Subject: Revised Individual Permit Application and Request for the lifting of "On Hold" Status for the Section 401 Certification for the upgrade of existing Mallard Creek Road (SR 2467) from H.T. Harris Boulevard (SR 2665) to the intersection of Hubbard Road (SR 2494) and continuing southeast on new location to Sugar Creek Road (SR 2480) with an additional extension from Rumble Road (SR 2501) to Neal Road (SR 2498) in Mecklenburg County. Federal Aid Project No. STPDA-5238 (4) & (5), Division 10, TIP U-2507 A, WBS 34811.2.3.

Reference: Section 404 and 401 Permit Application dated December 16, 2011.
NC DWQ Incomplete Application Notification ("On-hold" Notice) dated Feb. 15, 2012.

SUBJECT: Proposed Upgrade of Existing Mallard Creek Road (SR 2467) from H.T. Harris Boulevard (SR 2665) to the Intersection of Hubbard Road (SR 2494) and Continuing Southeast on New Location to Sugar Creek Road (SR 2480) with an Additional Extension from Rumble Road (SR 2501) to Neal Road (SR 2498), Federal Aid Project No. STPDA-5238(4) & (5), WBS 34811.2.3, TIP U-2507A, Mecklenburg County, DWQ No. 2011-1102

Revised February 2012
Permit Drawing
Sheet 15 of 23

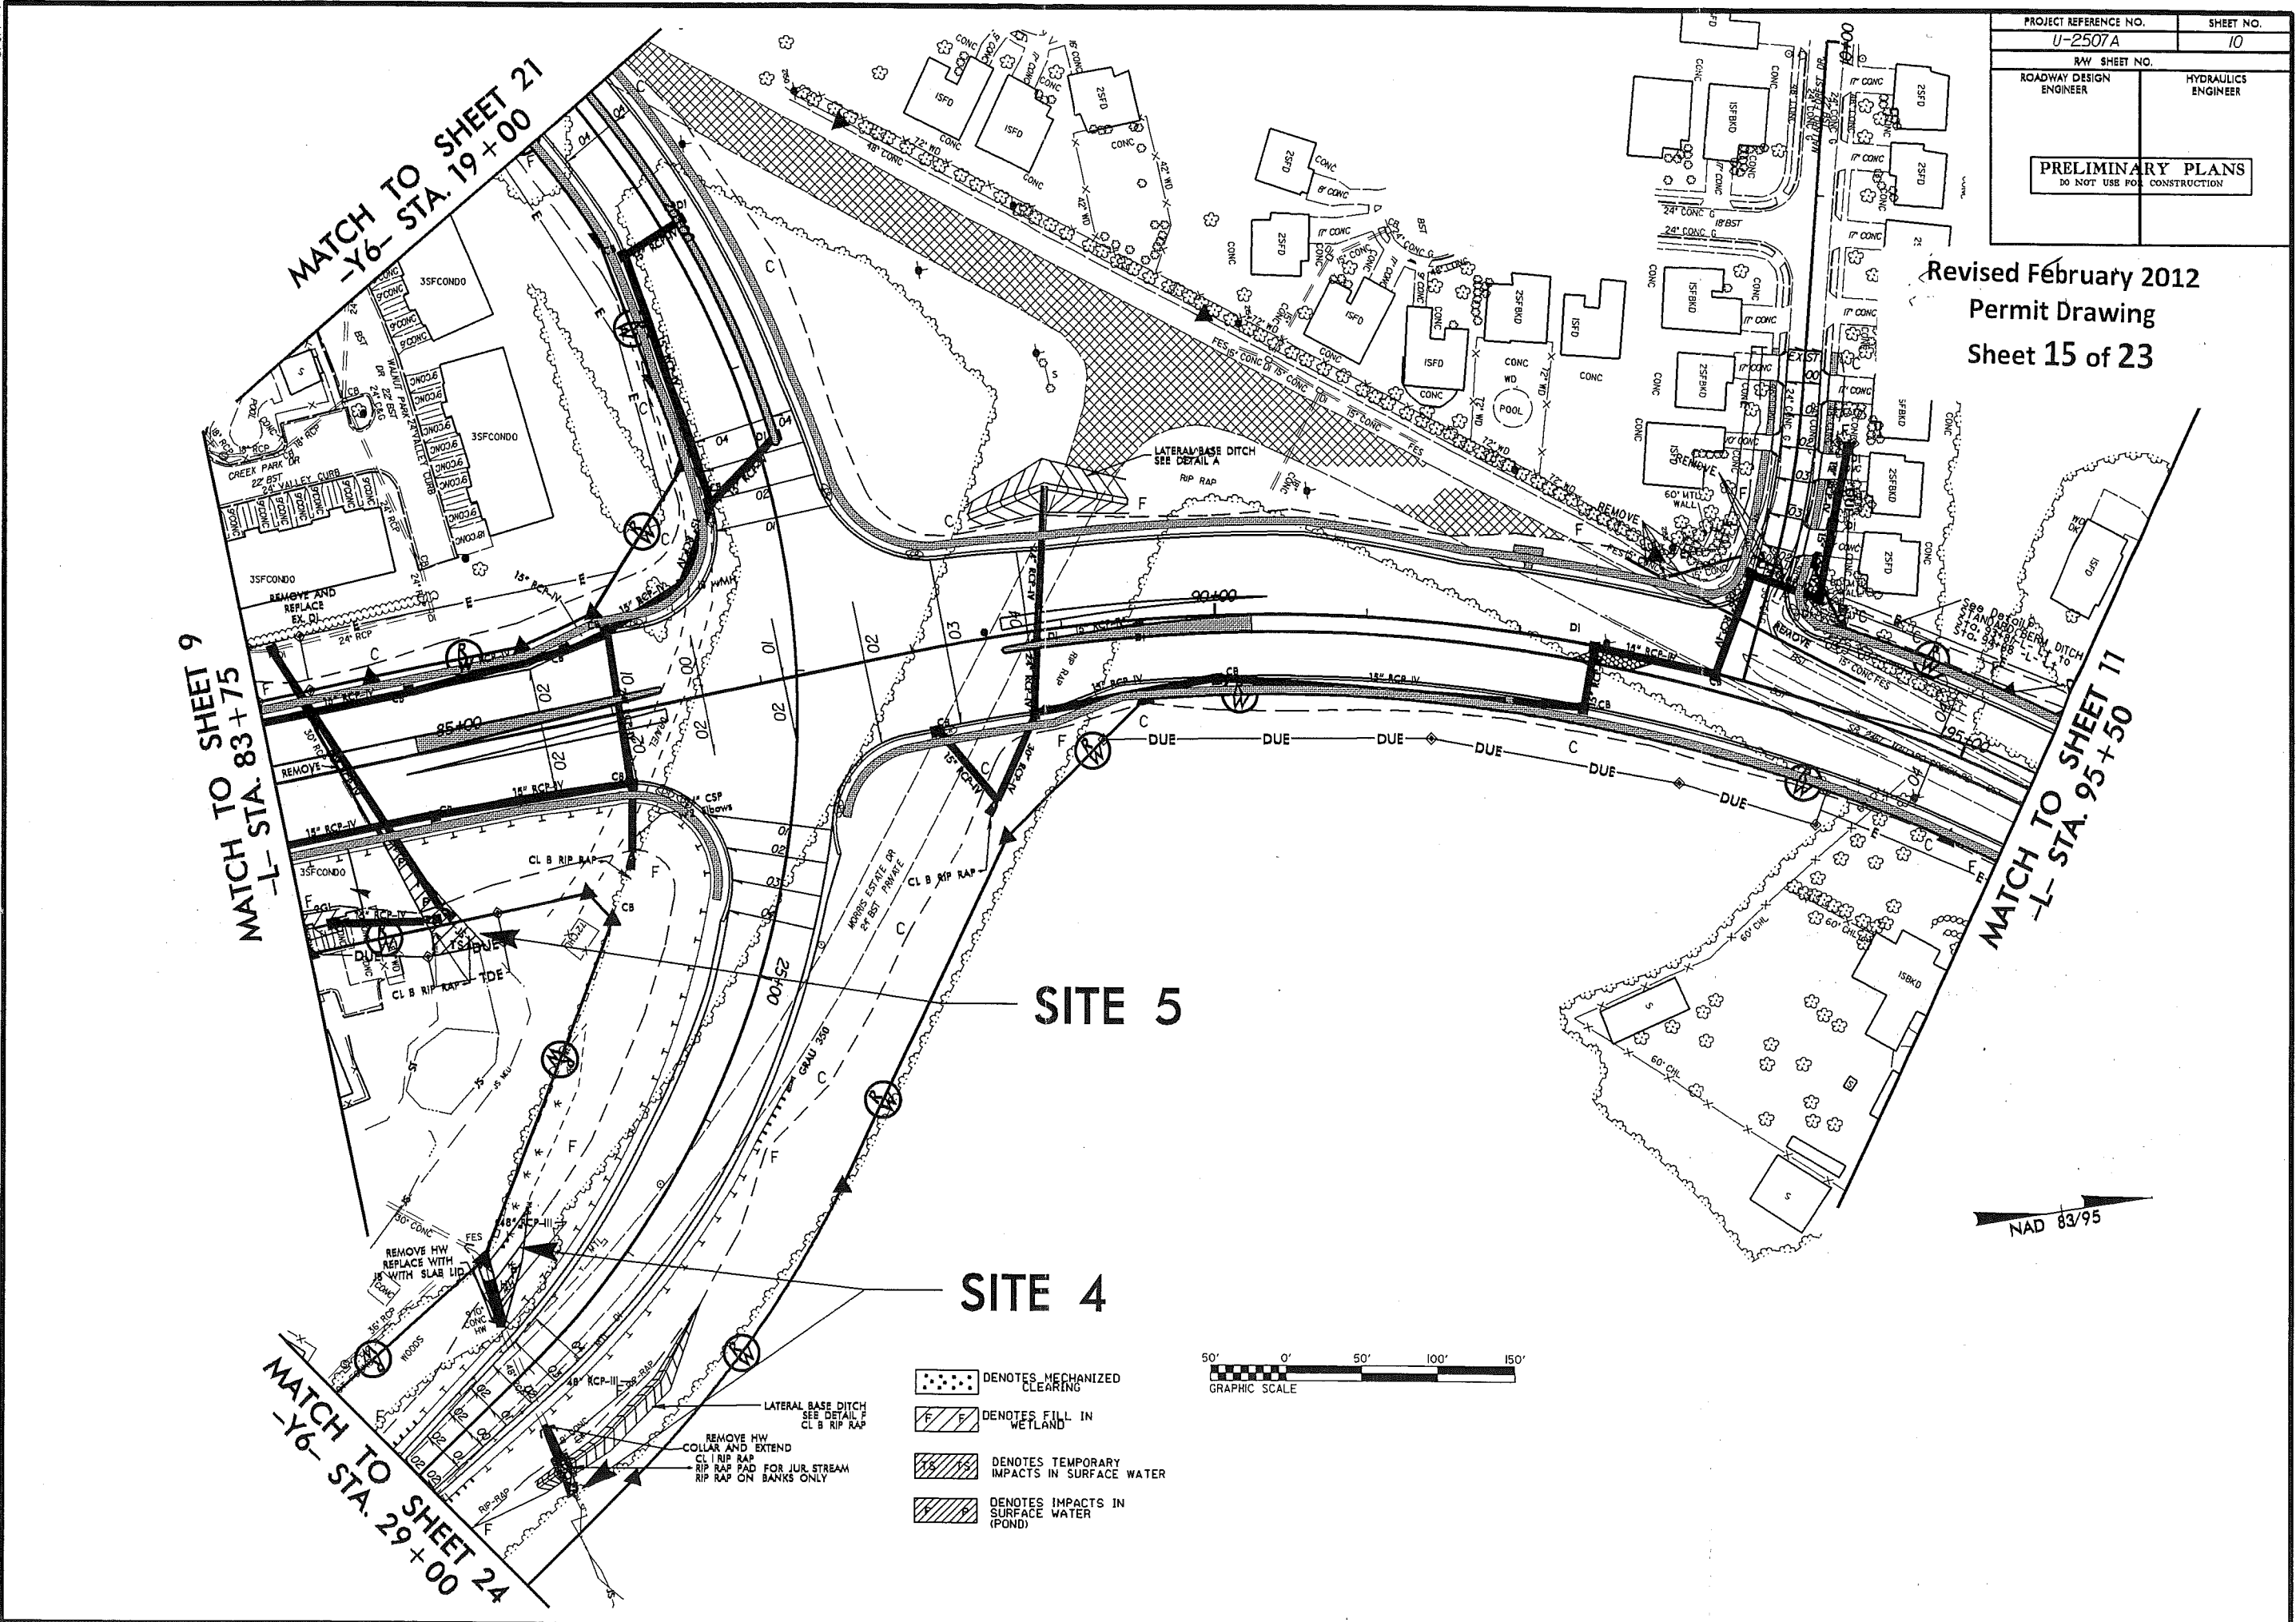
7. Permit Drawing Sheet 15 of 23 depicts indicates the use of "Rip Rap Pad for Jur. Stream" and "Rip Rap on Banks Only". DWQ prefers that all riprap be restricted to the stream banks. If riprap is proposed in the streambed, it must be embedded below the streambed elevation to allow for low flow of water and aquatic passage.

7. Permit Drawing Sheet 15 or 23 depicts indicates the use of "Rip Rap Pad for Jur. Stream" and "Rip Rap on Banks Only". DWQ prefers that all riprap be restricted to the streambanks. If riprap is proposed in the streambed, it must be embedded below the streambed elevation to allow for low flow of water and aquatic passage.

"Rip rap pad for jurisdictional stream" is another term for placing rip rap on the banks only.
